Heart of America Northwest, Commenter ID No. W552 (cont'd)

Appendix J: Comment Response Document

Figure 1: Tc-99 release over the 10,000-year compliance period based on results (a) WSRC-STI-2007-00055 and (b) the 2009 PA model results

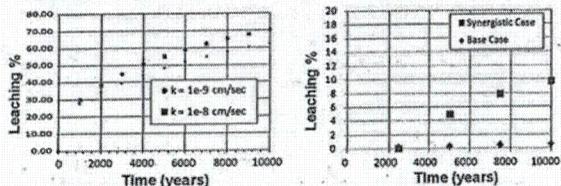
Basis: As discussed in WSRC-STI-2007-00056, experiments on Tc-99 leaching from saltstone simulated grout were conducted and the results incorporated into PORFLOW modeling. Figure 1 shows the modeled release of Tc-99 according to WSRC-STI-2007-00056 and the 2009 Saltstone PA. The modeled Tc-99 release for WSRC-STI-2007-00056 is approximately 60% over the 10,000-year compliance period for saltstone with a hydraulic conductivity of $1E-9$ cm/s, which is slightly less than the assumed hydraulic conductivity in the 2009 PA of $2E-9$ cm/s. According to the PORFLOW model files in the 2009 PA, the predicted release of Tc-99 from the saltstone material is 0.6% for the base case and 9.6% for the synergistic case.

transport of gas and liquid-phase oxygen to the fractured vaults and saltstone. In addition, the saltstone grout has been shown to be fractured which would increase the surface area-to-volume ratio, thereby increasing the oxidation of saltstone.

NRC staff recognizes that research is ongoing and that the results presented in Figure 1 below are based on a modeled system. However, this model is parameterized from experimental results conducted with a saltstone simulant whereas the shrinking core model utilized in the PA is less empirical. Additionally, some key parameters of the shrinking core model, such as the $T_c K_d$ are based on a formulation that is drastically different than saltstone (see SP-15).

Path Forward: The PA should be consistent with relevant research or justification should be provided discussing why it was excluded. Provide any additional references on Tc-99 leaching from saltstone that have not already been provided to the NRC.
